COMMUNITY DEVELOPMENT DEPARTMENT REPORT

SUBJECT: Storm Crest
H-2026-0024

Annexation of 11.438 acres of land with R-15 zoning district and a preliminary plat consisting of 71 buildable lots and 14 common lots.

E. Landscape Plan (date: 5/4/2026)

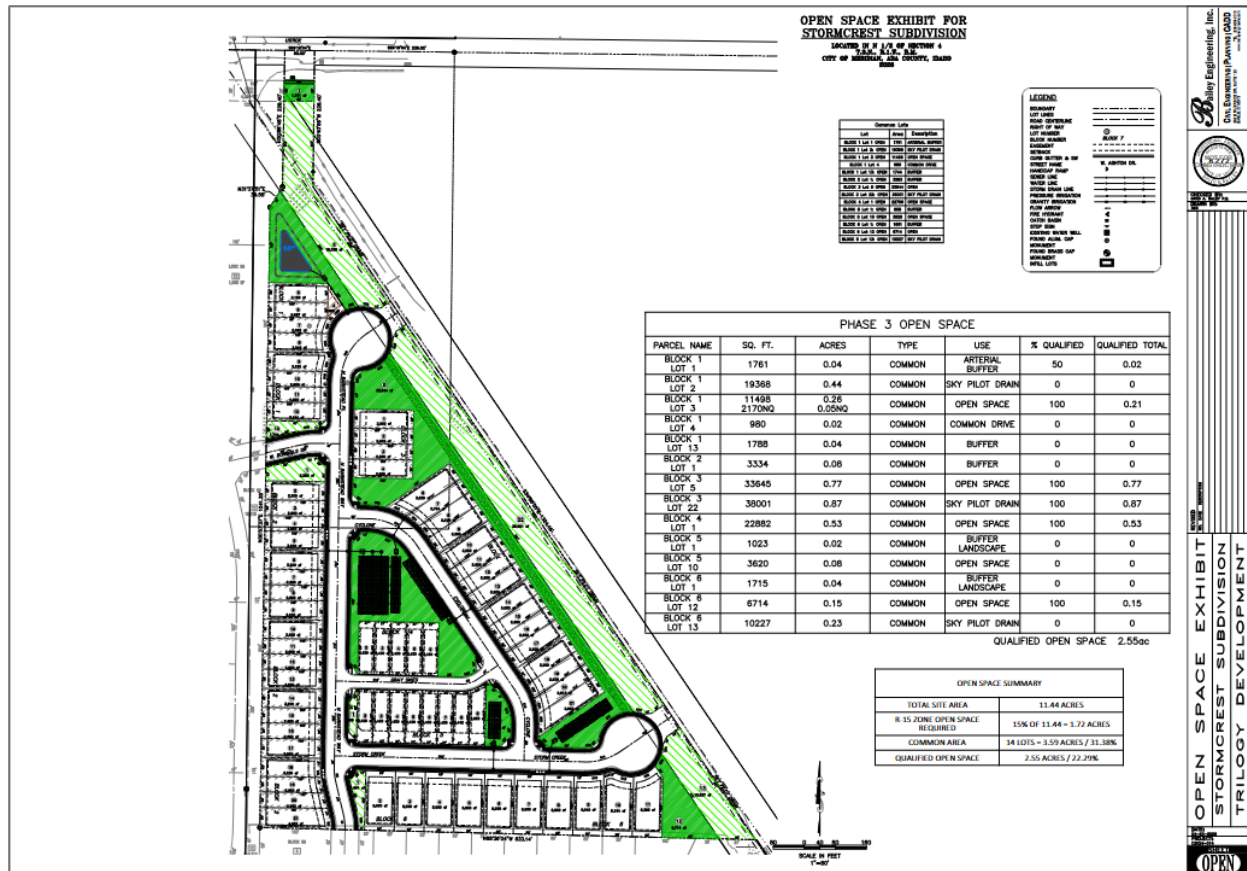
The proposed landscape plan shows the narrow strip of land along Ustick Road with a 35-foot buffer. However, a portion of the landscape buffer is inside of the Sky Pilot Drain easement which may affect vegetation coverage. If the applicant cannot meet the vegetation coverage requirements, alternative compliance shall be submitted with the final plat application.

The applicants landscape plan shows 118 caliper inches may need to be mitigated for. Prior to the Final Plat application being submitted, the applicant shall have the City Arborist verify which trees need to be mitigated for and which do not.

The applicant is proposing a ten (10) foot multi-use pathway along the Sky Pilot Drain. The applicant is proposing landscaping that appears to meet the requirements in UDC 11-3B-12; however, the applicant did not specify the type of landscaping in the planter bed along the west portion of the pathway. The applicant shall revise the landscape plan to more clearly depict the type of landscaping with the final plat record.

Additionally, because the front yards of the subject lots are oriented away from the alley, staff recommends that Lots 2–9, Block 5 include a detached sidewalk and an eight (8)-foot parkway along Storm Creek Road. This improvement would provide a more pedestrian-friendly environment and enhance connectivity along the roadway.

3. The landscape plan submitted with the final plat shall include the following revisions:
- a. Include mitigation calculations on the plan for existing trees that are proposed to be removed in accord with the standards listed in UDC 11-3B-10C.5. The Applicant shall coordinate with the City Arborist (Kyle Yorita kyorita@meridiancity.org) to determine mitigation requirements prior to removal of existing trees from the site.

- b. A portion of the landscape buffer is inside of the Sky Pilot Drain easement which may affect vegetation coverage. If vegetation coverage requirements cannot be met, the applicant shall apply for alternative compliance with the final plat application.

- c. Provide landscaping in the planter bed along the west portion of the pathway in compliance with UDC 11-3B-12.
 - d. Add a eight (8) foot parkway and five (5) foot detached sidewalk along the front of Lots 2-9, Block 5.

- e. Revise the fencing along the front yards of Lots 2-6, Block 4 to either be removed or 4 foot open vision fencing.
 - f. Extend the multi-use pathway along the Sky Pilot Drain through Lot 3, Block 1 to connect with the stub in the Dayspring Development to the west.
